UNITED STATES PATENT AND TRADEMARK OFFICE

10/572,611

Office Action Summary	Application No. 10/572,611	Applicant(s) PETRUZZELLO ET AL.	
	Examiner Michael B. Shingleton	Art Unit 2815

DETAILED ACTION

FIG. 8

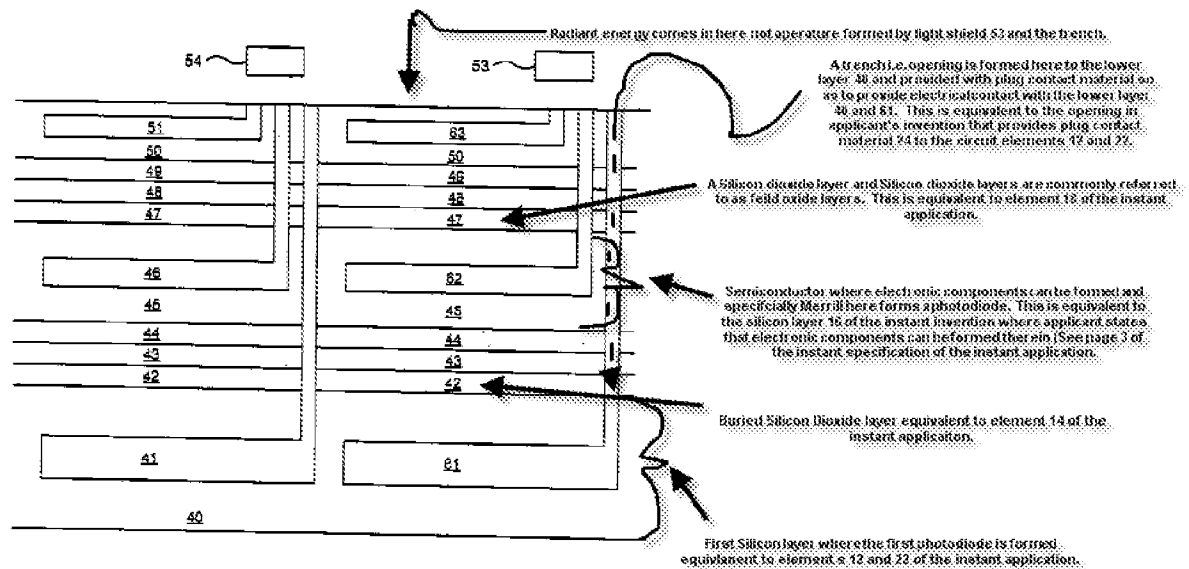
Figure 8 and the relevant text of Merrill disclose a silicon on insulator (SOI) photodiode and method of forming a SOI photodiode. The basic structure of the photodiode of the instant application is that of a common stacked multiple color photodetector. While the present applicant hints at the filtering, controlling the depth of the layer or layers, etc., this basic structure of the invention applies the well known (conventional) principles of stacked multiple color detectors. What happens in a stacked photodiode multiple color photodetector is that the higher frequency light signals (Sometimes referred to as “higher energy” light signals by some because of $h \cdot \nu$.) gets absorbed quicker than the lower frequency light components, so the upper detector(s) detect the higher frequency component(s) like blue and as these higher frequency components like blue are all absorbed before they reach the lower frequency light detecting components like red. (See for example see the Figure illustrated on the cover of Merrill '050 and note that Merrill '050 is as only being cited to further emphasis this well known and common principle in stacked photodiode multiple color detectors.) In the actual Merrill reference applied herewith as rejecting the disclosed structure and associated method of forming the structure, filters like 43 and 48 are also used to ensure that the higher frequency components do not reach the lower frequency detector(s). As also noted in the original disclosure of the instant invention electronic components can be formed in the layer 16 of the instant invention and it is a fact that a p-n diode that detects light energy is an electronic component (See page 3, around line 21 of the instant application.). So while the instant application does not hint at stacked photodiode photo-detectors, (The addition of such in the original

disclosure would possibly be new matter as a broad recitation of "electronic components" in layer 16 does not necessarily mean that applicant actually invented or had actually made the invention where the electronic component in layer 16 is a photodiode. However, maybe from the stacked photodiode art applicant got the idea of forming electronic components in the silicon layer that is isolated from a lower photo diode layer by a silicon dioxide layer.), it was this passage that has clued in the examiner that the structure of the instant application exists or could possible exists in the stacked photodiode photodetector art.

The invention of Merrill discloses a silicon substrate 40 that is formed having a first portion doped "p" and the second portion 61 doped "n". This clearly forms a p-n junction and since the junction has both vertical and horizontal components, this can't help but have a "vertical pn junction". The silicon dioxide layer 42 forms a buried oxide layer and is clearly formed on the silicon substrate 40. There is a silicon layer 45 that is formed on the buried oxide layer. The functional language "wherein the amount of incident light passing through the SOI photodiode to the silicon substrate with respect to wavelength is proportional to a thickness of the silicon layer" does not add anything to the claim(s) for as stated above this is just an inherent property of the arrangement. It is the whole principle upon which stacked photodiodes work. The layer 47 that is formed on the silicon layer 45 being of silicon dioxide is a "field oxide layer". Silicon dioxide material is what is commonly referred to as a field oxide layer. The function of "wherein a thickness of the field oxide layer controls the thickness of the silicon layer" is like the functional language above that does not add anything to the claimed invention as stated above as this is just an inherent property of the arrangement. It is the whole principle upon which stacked photodiodes work. The "plug contacts" are formed in "trenches" that extend to the silicon substrate and it goes without saying that a contact is formed in the trench otherwise "plug contacts" would have a different name. Also note that Figure 15G of Merrill specifically calls the opening to the lower layers of a stacked arrangement a "trench". The examiner must read terms broadly with their plain meaning when applicant does not provide a specific definition that is different from the plain meaning of the term, i.e. a definition that defines something as something and only that something and that something is different from the plain meaning of the term. Thus if applicant wanted the term "trench" to designate some other structure than the plain meaning of the term as evidenced by even Merrill himself, then in accordance with recent case law to Halliburton Energy Services, Inc. v M-I LL, Fed. Cir., 2007-1149 Halliburton decision the court says **"We note that the patent drafter is in the best position to resolve ambiguity in the patent claims, and it is highly desirable that the patent examiners demand that applicants do so in appropriate circumstances so that the patent can be amended during prosecution rather than**

With respect to claim 14, the doping of layer like 61 has to occur prior to the forming of the contact. Note that contact plug includes the metallization on the top thereof. Also note Figures 15E to 15H of Merrill here the doping of the "lower" layer 41 is provided, i.e. is formed before the trench is formed and then after the trench is formed the contact material is formed in this trench to form this "plug contact" to the lower layer. Same claimed structure and method of manufacture as disclosed and claimed is clearly disclosed by Merrill, i.e. applicant forms the lower layer 12 first and then provides an opening to the lower layer 12 and then forms a plug contact 24 to the lower layer 12 so that this lower layer is electrically contacted to the outside world.

With respect to claim 12, the contact in combination with the light shield 53 forms i.e. defines "an" aperture of the SOI photodiode. Note that there can be other apertures and the claims do not exclude other things as defining an aperture.

Note the following additional comments are made to help in the furthering of the prosecution of the instant application and help guide applicant to form an allowable amendment should applicant decide to amend the application. Applicant may try to amend the claim to state that the instant invention does not include a third silicon region similar to that of region 50 in Merrill, but applicant should take note that it has long been established in case-law that the elimination of something along with the elimination of that feature/function is generally obvious. So clearly to make a two color detector one would drop the top detector of a three detector device. That would be one way to do it that lies within routine skill in the art.

Also elimination of a feature not needed, like for example should applicant say that the invention lacks "color filters" when the thickness of the layers ensure the color filtering function like for example in Merrill '050, is another situation where the elimination of something along with the elimination of function would have been obvious. Given that the disclosed invention and the prior art invention are so very close in structure and function it is hard for the examiner to identify something in this case which would make the claims if added to the claims allowable. The diffusions 22 at each end of the device if specifically claimed is different from the prior art cited but the examiner cannot be sure that such a feature is not out there, i.e. would have been obvious or anticipated by prior art.
